XE166N Derivatives

16-Bit Single-Chip
Real Time Signal Controller
XE166 Family / Value Line

Errata Sheet

V1.3 2009-06

Figure 1 Loss of Arbitration

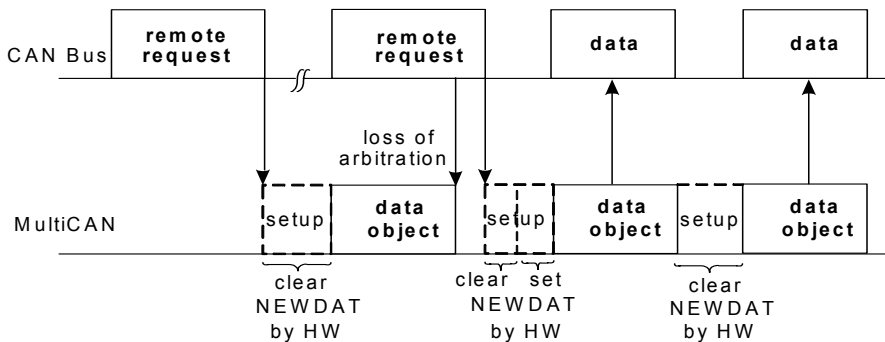
MultiCAN_TC.H004 Double remote request

Assume the following scenario: A first remote frame (dedicated to a message object) has been received. It performs a transmit setup (`TXRQ` is set) with clearing `NEWDAT`. MultiCAN starts to send the receiver message object (data frame), but loses arbitration against a second remote request received by the same message object as the first one (`NEWDAT` will be set).

When the appropriate message object (data frame) triggered by the first remote frame wins the arbitration, it will be sent out and `NEWDAT` is not reset. This leads to an additional data frame, that will be sent by this message object (clearing `NEWDAT`).

There will, however, not be more data frames than there are corresponding remote requests.
